From: Jonathan Talley <jon@jtalimited.co.uk>
Sent: 22 January 2025 10:08:15 UTC+00:00
To: "Anna Tidey" <Anna.Tidey@midsussex.gov.uk>
Subject: Re: 2025.01.13 Re: DM/24/2933 - 23 Meadow Drive Lindfield Haywards Heath
West Sussex RH16 2RS

From: drainage <drainage@midsussex.gov.uk>
Sent: 09 January 2025 13:13
To: Anna Tidey <anna.tidey@midsussex.gov.uk>
Cc: drainage <drainage@midsussex.gov.uk>
Subject: RE: DM/24/2933 - 23 Meadow Drive Lindfield Haywards Heath West Sussex RH16 2RS

Thank you for consulting the Flood Risk and Drainage Team with regard to the above application. We understand the application is for demolition of existing garage and erection of a two storey rear and side extension and new front porch. The Flood Risk Assessment provided by the Applicant has been reviewed, and we would comment as follows:

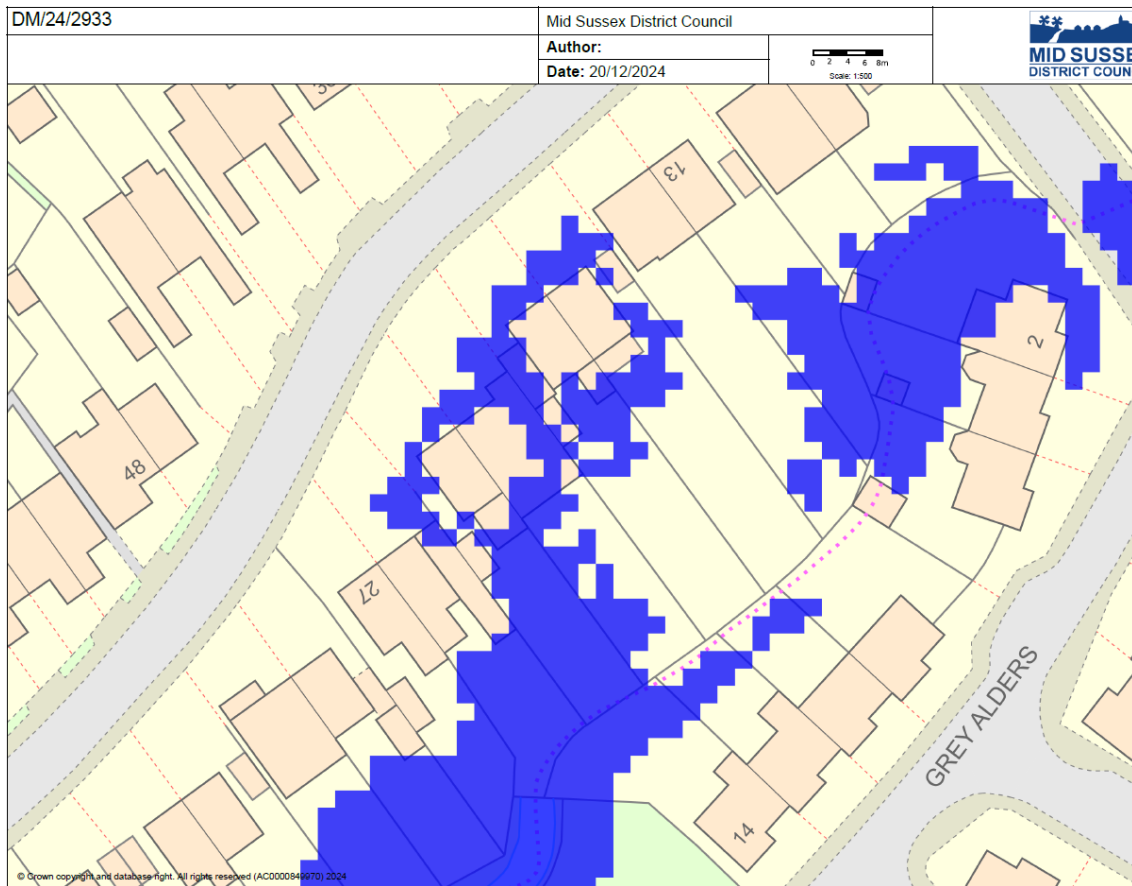
Based on the latest guidance that all sources of flooding should be considered consistently the site meets one of the reasons an area would be considered functional floodplain (Flood Zone 3b); it's location within the 1:30 surface water flood extent.

It is the Flood Risk and Drainage Team's findings that, following the latest guidance on assessing flood risk the site is located within the equivalent of Flood Zone 3b (1:30 flood extent) and the proposed development is a more vulnerable development.

As per the Environment Agency standing advice for minor extensions, development within the 1:30 flood extent is not permissible.

- In order to assist please see above extract from our Environment Agency mapping of the surface water flood extents. There is a publicly available searchable and downloadable maps available: Defra Data Services Platform (select the relevant layers for the 1:30, 1:100 and/or 1:1000 extents) Please could the Applicant overlay their proposed extension footprint on the above (or similar) screenshot of the 1:30 flood extent for us to review any encroachment?

If the proposal is outside of this extent then additional resistance and resilience mitigation will need to be evidenced at this location, as this development is classified as 'more vulnerable'.

In addition, the Flood and Drainage Team would have no objection to the scheme if surface water modelling can be provided which demonstrates that the development design ensures that, for the 1:100 year + climate change event:

- Site users are safe in the event of a flood
- There is no loss of floodplain storage
- There is no impedance of overland flows
- There is no increase in flood risk
